**6. Jelinek Subdivision; KPB File 2023-035**

ITEM 6 - JELINEK SUBDIVISION

<b>KPB File No.</b>	2023-035
<b>Plat Committee Meeting:</b>	April 24, 2023
<b>Applicant / Owner:</b>	Stephen Jelinek and Lesa Hall, Anchorage, Alaska
<b>Surveyor:</b>	John Segesser / Segesser Surveys Inc
<b>General Location:</b>	Kenai Spur Highway, Aspen Court, Spruce Grove Avenue, Nikiski, Nikiski APC

STAFF REPORT

Jelinek Subdivision

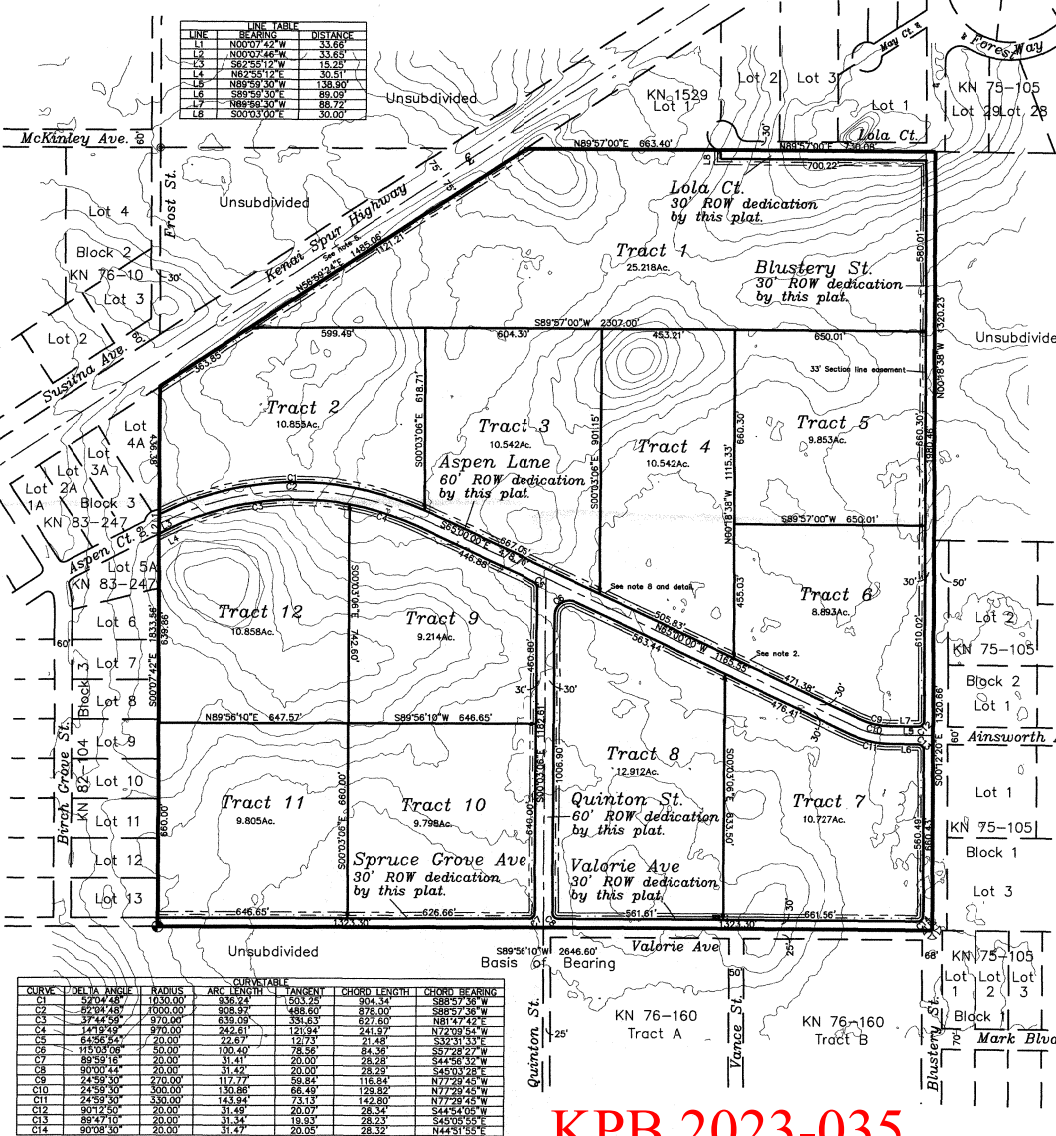
The preliminary plat shows multiple lines along the rights-of-way. ***Staff recommends the line styles be added to the legend for clarity.*** Along the eastern boundary is a label for a 33 foot section line easement. It is difficult to determine where the leader is pointing. Per data available to the KPB, it does not appear that there is a section

line easement present within the bounds of the subdivision, but there is one adjacent to the eastern boundary that provides a full width for Blustery Street. **Staff recommends** the owner/surveyor work with the State of Alaska DNR to determine the easement widths within and abutting the property and correct depiction and labeling be added.

Per the Certificate to Plat there is a right-of-way lease within the subject property. **Staff recommends** the owner/surveyor determine the location of the lease and provide a depiction and plat note if within the subdivision. If the lease is found within a dedication, provide a plat note with the document information and state which dedication it is found within.

**Site Investigation:** The terrain is relatively flat with some steeper terrain located in a few locations. It does not appear that any of the terrain within the lots exceeds 20 percent. The lots are large enough that the slopes present should not impact development or access. **Staff recommends** the contour information within the lots is not required.

A low wet area designated as a depression is located within proposed Tract 12. The depiction appears to be lacking but it may be due to the contour information. **Staff recommends** the low wet area be depicted on the final plat and a wetland determination note be added.

There does appear to be some steep slopes present within the northern portion of the Blustery Street dedication. **Staff recommends** centerline profiles and cross-sections be provided for review to determine if additional easements or dedication width are required.

**Utility Easements** There are no platted utility easements to carry forward. This plat will be granting 10 feet adjacent to the right-of-way dedications that increase to 20 feet within 5 feet of the side lot lines as utility easements. It appears a depiction of the easement and setback are on the face of the plat but no labels are present. **Staff recommends the lines be labeled or added to the legend.**

A typical drawing is used to show the setback and easements being granted by this plat. **Staff recommends the 10 foot label be updated to 20 for the correct depiction of the building setback.**

- Correct any overstrikes on the face of the plat and clean up the linework.

**Staff recommendation:** *Correct the legal description to include the excepting therefrom verbiage.*

**Staff recommendation** *Correct Forest Way to Aleutian Court. Correct the width label for Valorie Avenue. Per information available to KPB, the subject property is not subject to section line easements. The unsubdivided property located to the east is subject to a section line easement. Verify any section like*

*easements within and abutting, depict and label. Increase the font on some of the labeling as it does not comply with state requirements and are difficult to read.*

**Staff recommendation:** *Include a label for the township and range*
- G. The status of adjacent lands within 100 feet of the proposed subdivision boundary or the land status across from any dedicated rights-of-way that adjoin the proposed subdivision boundary, including names of subdivisions, lot lines, block numbers, lot numbers, rights-of-way; or an indication that the adjacent land is not subdivided;

**Staff recommendation:** *Add block 2 label to the subdivision to the northeast, Field Subdivision No 1. Correct lot 1 of the same subdivision to lot 7. Correct the overstrikes in lots 28 and 29 Forest Hills Subdivision Part 2.*

**Staff recommendation:** *There is a small depression area located within proposed Tract 12. The wetlands will need to be depicted on the final plat and a wetland determination note will be added.*

**Staff recommendation:** *Contours are present. The plat does not indicate the contour measurements.*

**Staff recommendation:** *It appears that there may be slopes greater than 10% within the proposed dedication for Blustery Street. Submittal of centerline profiles and cross-sections should be submitted for rights-of-way containing steep slopes for review to determine if additional dedicated width is needed or maintenance/slope easements.*

- B. A minimum 100-foot tangent is required between curves.  
**Staff recommendation:** *The design of Aspen Lane needs revised adjacent to the Aspen Court dedication to connect to the existing curve correctly. The dedication for Lola Court shall be revised so that there is not a 90 degree and provides smooth and compliant connection to the existing dedication.*

- Provide the reference to KPB code to plat note three.
  - Add in front of the book in note 7 "misc."
  - There is a right-of-way to lease noted within the certificates replat. A plat note should be added.
  - Any person developing the property is responsible for obtaining all required local, state, and federal permits, including a U.S. Army Corps of Engineers wetland determination if applicable.
-
